E8362A-01C**S E R V I C E****N O T E**Supersedes:
E8362A-01B**E8362A PNA Series RF Network Analyzers**

Serial Numbers: 00000000 thru 46999999

December 6, 2007

Figure 1

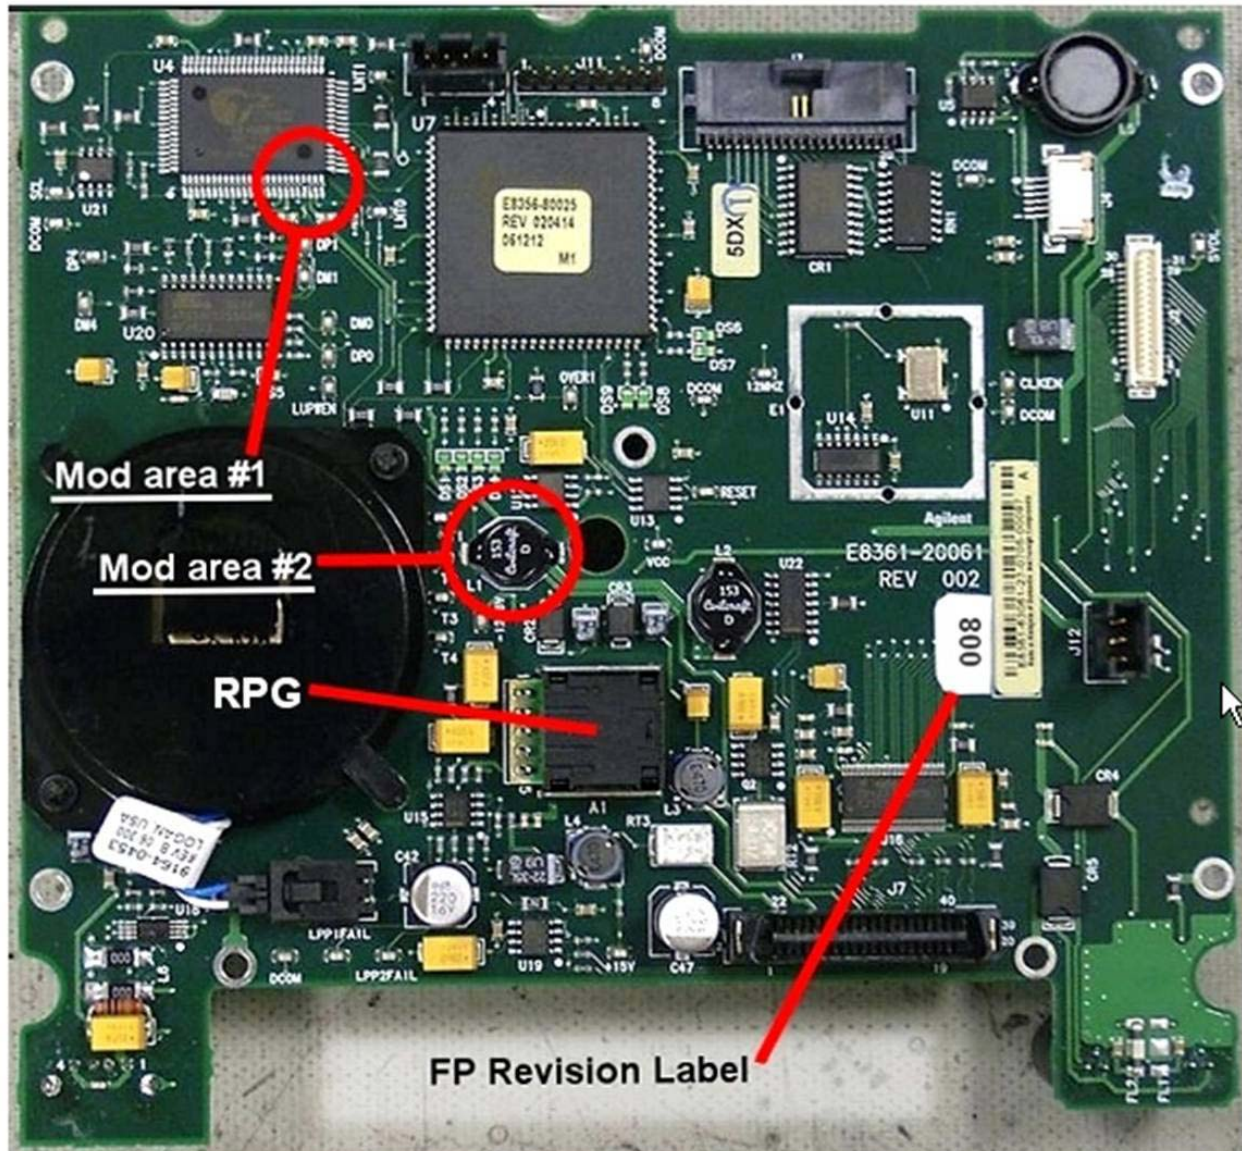
Refer to Figure 1 for the two modification areas to be addressed. Note that while this picture happens to show the FPI board completely removed from the front frame assembly, this is not necessary to perform the required modifications.

- Modification #1 consists of shorting two pins of U4 together with a small amount of solder.
- Modification #2 consist of removing L1.

Unsolder and completely remove the black surface mount inductor L1 from the front panel assembly board. This is no longer needed and can be discarded.

Figure 2

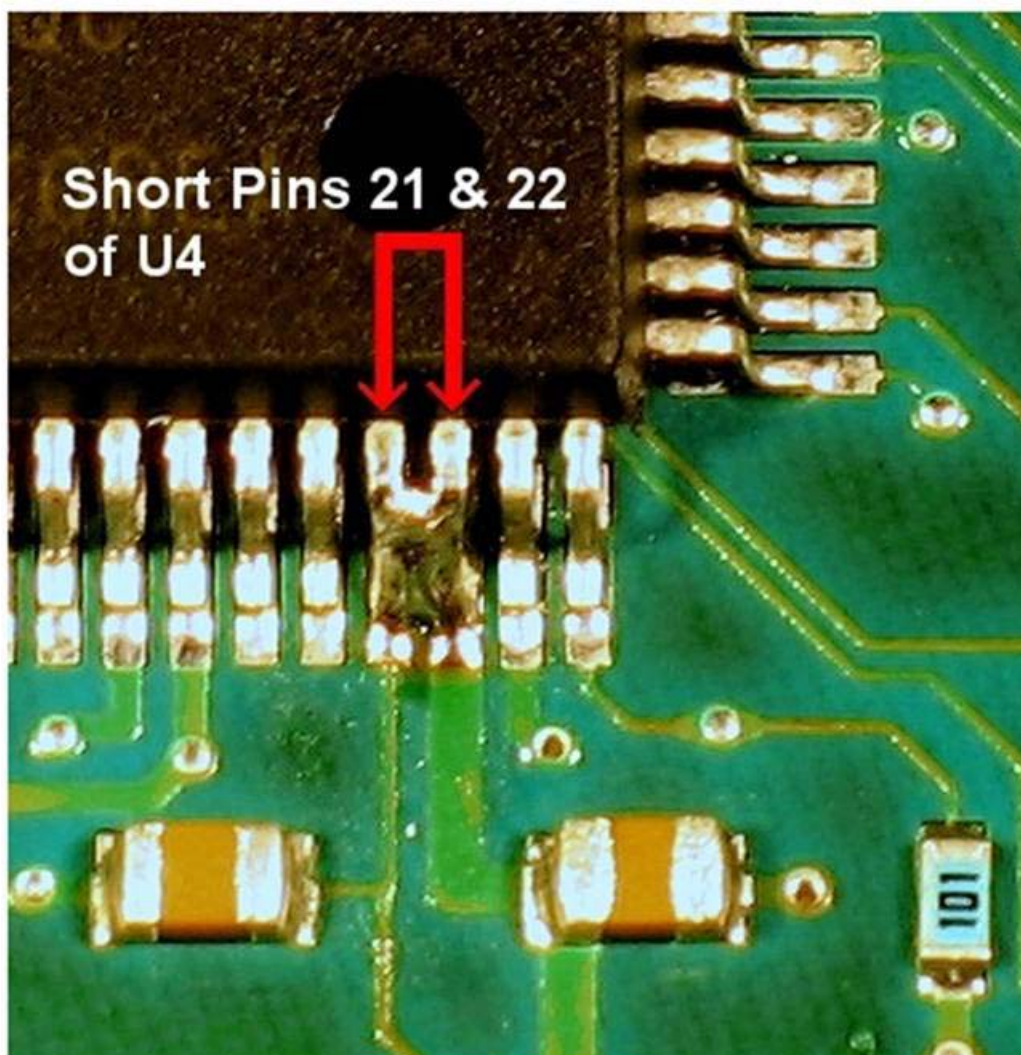
Both intermittent problems have been traced to an incorrect voltage applied to a pin on the U4 IC.

Carefully solder pins 21 and 22 together on U4. Refer to Figure 2 for the exact location. Use care so that no other pins are shorted. Use of a very fine tip soldering iron is recommended and a large work-task magnifying glass is very helpful.
